BUS 2A & 3A INTERLOCKING RELAYS

WESTINGHOUSE ELECTRIC CORPORATION
FOR
CONSOLIDATED EDISON COMPANY
INDIAN POINT GENERATING STATION - UNIT NO. 3

SCHEMATIC DIAGRAM
480V. SWITCHGEAR 31

SHEET NO. 6

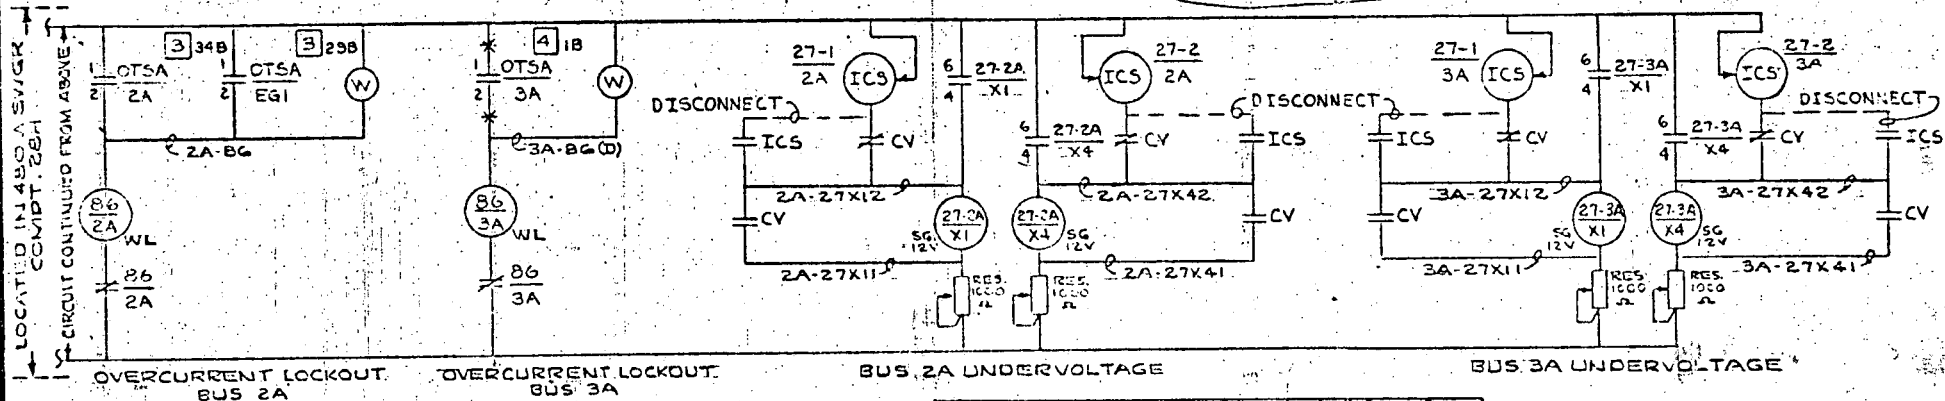
PER ITEM 2 OF EUP 367

NO.	DATE	DESCRIPTION	ENGR	SUP ENGR
6	11-74	REVISED PER ITEM 2 OF EUP 367		
5	11-73	ECN 700 BB TRAIN 1 & TRAIN 2 WERE INTERCHANGED		
4	7-71	REV. KEYS CONTACT NOS. WIRING NOS. TRAIN NOS. ADDED CABLE LTRS.		
3	3-71	REV. CABLE POS. & LTRS. BE SIGNED & 2111-831 WAS ER. (NOTE: 2111-831 WAS REV. 22-11-70)		
2	3-71	ADDED CABLE LTRS. & NOTES TO 22-11-70		
1	11-70	REVISED NOTE 4; ADDED WIRING NOS. & CABLE NOS. & WIRING LOC. NOS.		
0	11-70	FIRST ISSUE FOR CONSTRUCTION
